CITY OF BERKLEY, MICHIGAN REGULAR MEETING OF THE CITY PLANNING COMMISSION

1. **AMENDMENT TO PLANNED UNIT DEVELOPMENT PPUD-01-25: The Columbia:** The applicant, Krieger Klatt Architects on behalf of WJ Ventures LLC, 2465 Columbia, 2475 Columbia, 2468 Columbia and 2476 Columbia and 2475 Cambridge, is requesting an amendment to the Planned Unit Development previously approved for a multiple-family development on the east side of Coolidge Highway, south of Cambridge Road and north and south of Columbia Road
2. **Planning Commission Liaison for Chamber of Commerce**

The applicant has submitted an amendment to the approved Planned Unit Development for The Columbia. The project history is detailed in the Community Development Department review memo.

Thank you for the review of PUD Amendment for "The Columbia" project dated "02.13.2025 Revised PUD". Below are responses to your March 3, 2025 review letter. All responses will be cross referenced with revised documents dated "03.13.2025 Revised PUD - Rev. #1".

1 Building Section 1
A.100 1/8" = 1'-0"

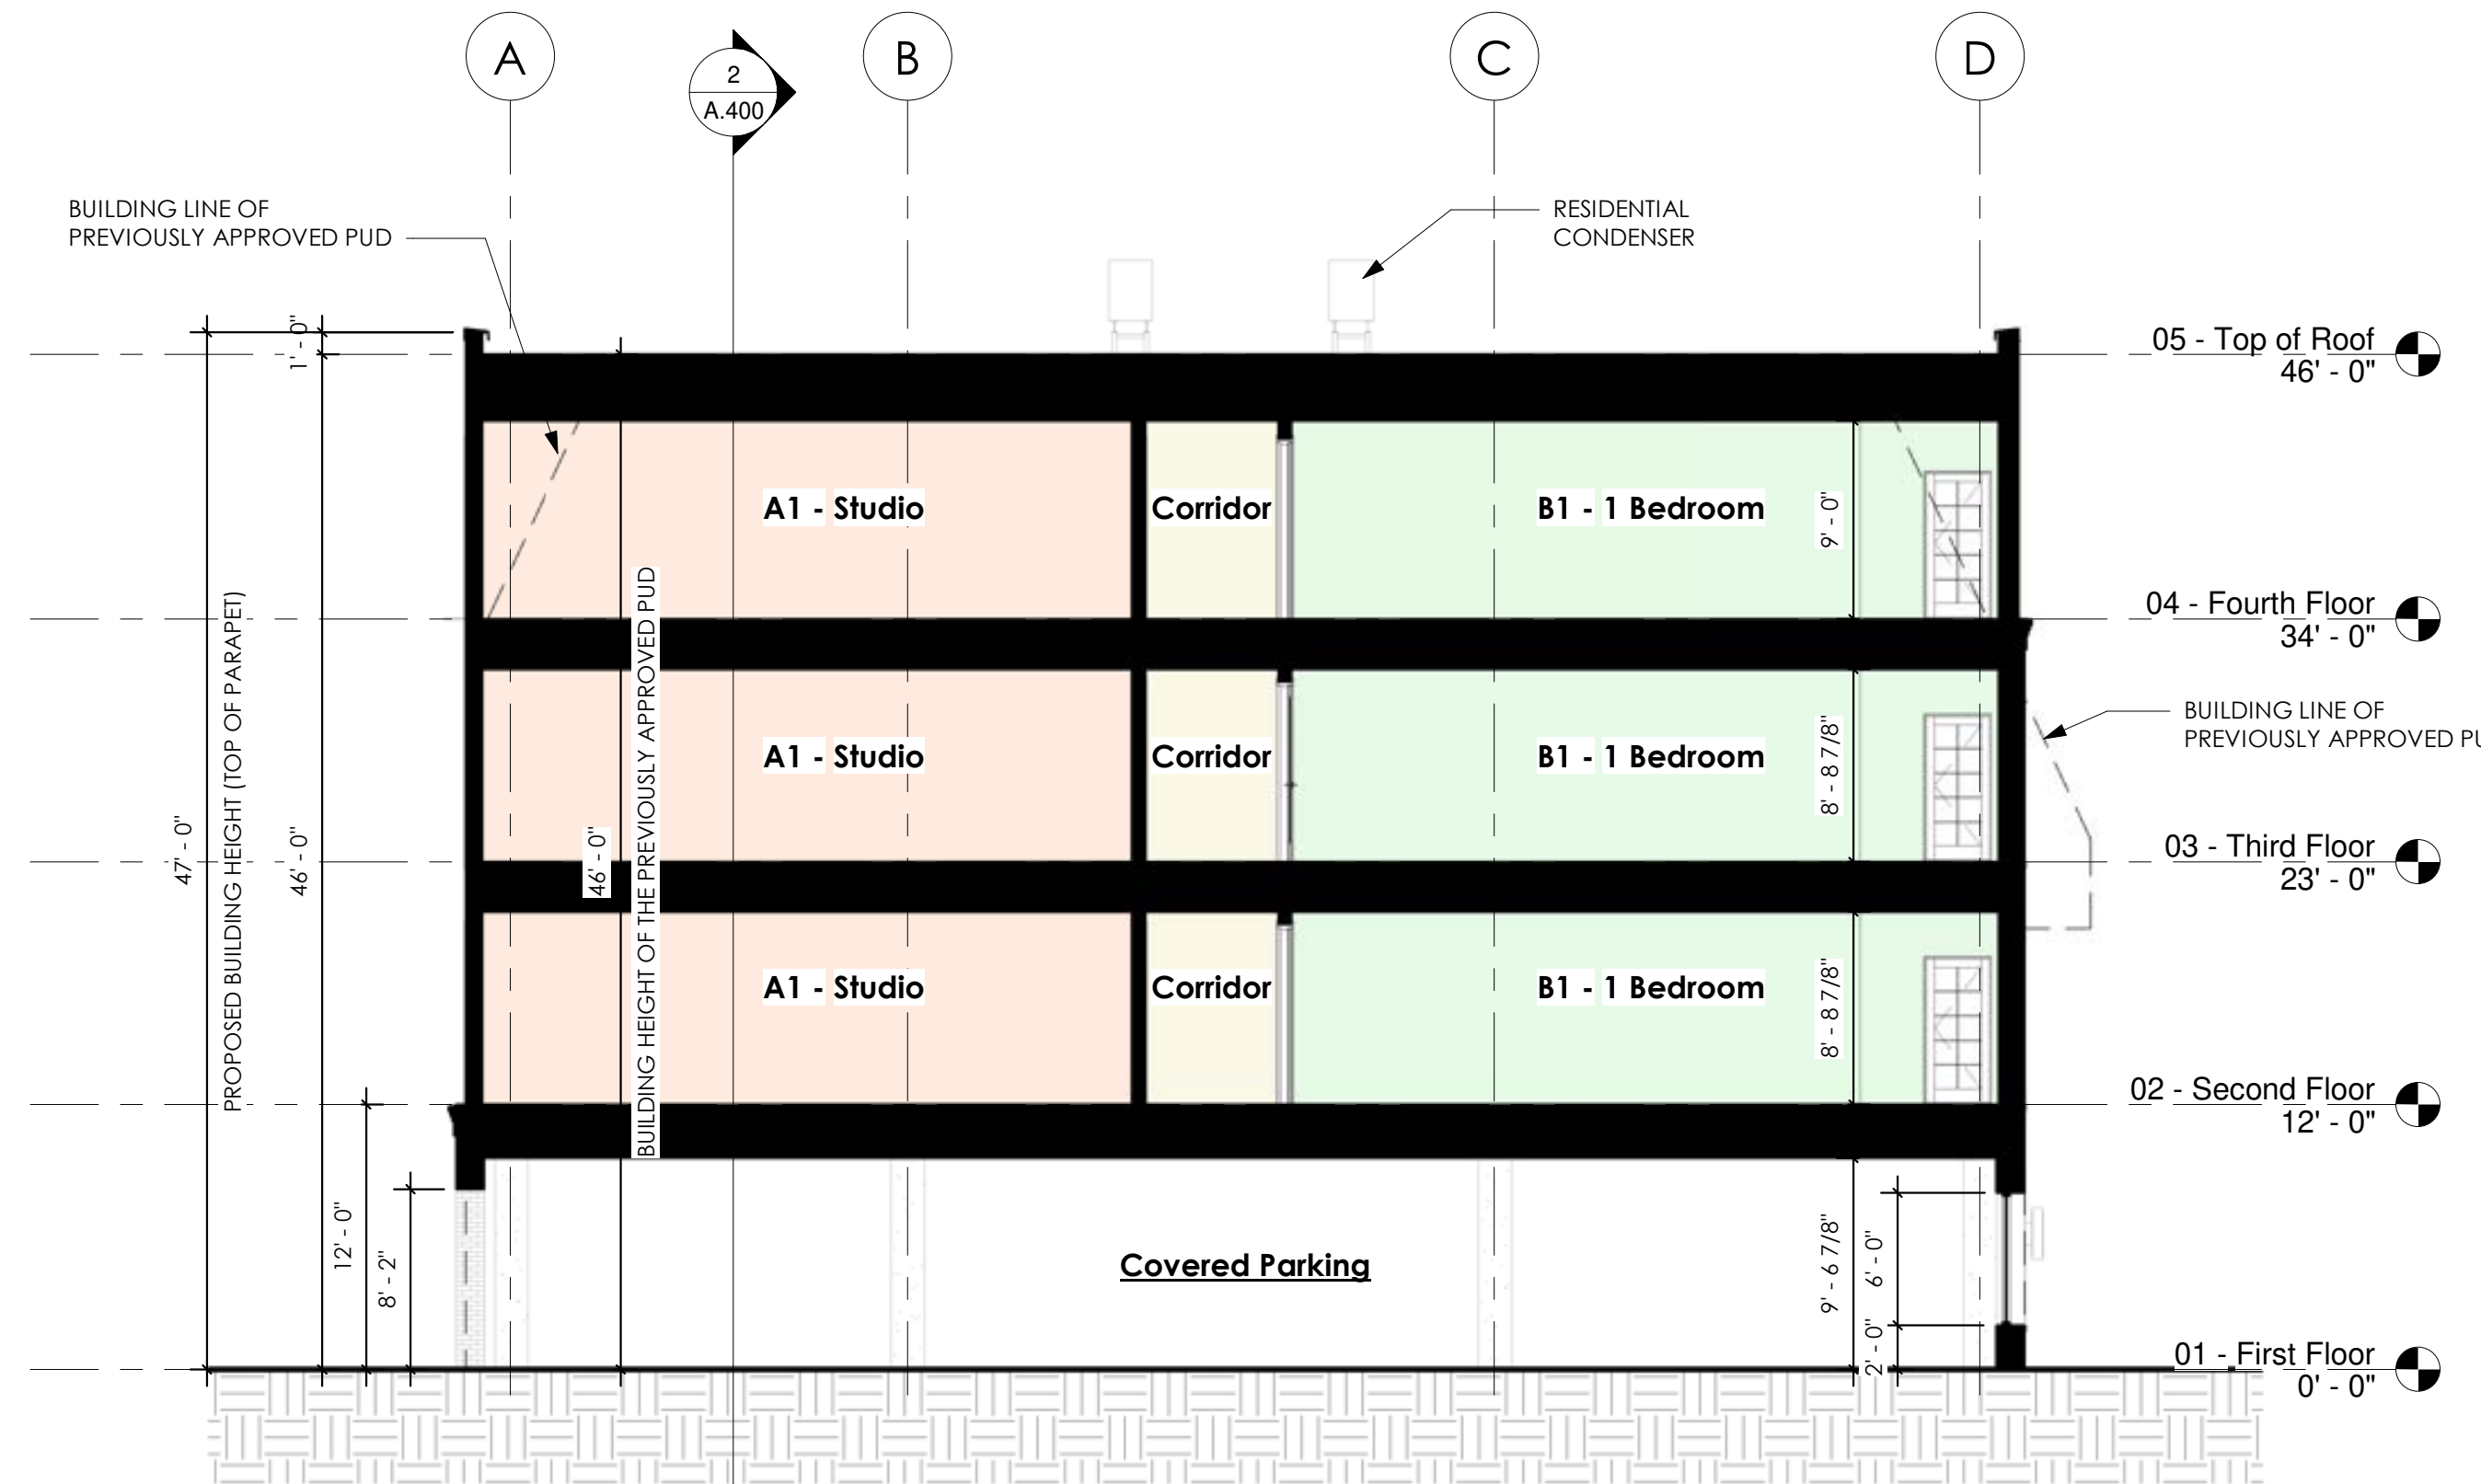
2. Building Revisions:
 - a. Per ordinance, the original PUD was using sloped walls on floor 4 to be classified as a "mansard roof" which allows the building height to be measured to the midpoint of the sloped "roof". This measured 40'-0" to the midpoint but the flat "deck" of the roof would have been 46'-0". The proposed building eliminated these sloped walls. The measurement to the top of deck is 46'-0" so, the building massing has not changed from the original PUD plans.

- i. Please see sheet **A.400** "Building Section 1" which contains an outline of the original PUD building. Note that the roof deck in the original plans was at 45'-0". This does not include the roof pitch. In our opinion, the original building would have had a roof deck height of 46'-0" which matches what we are proposing.
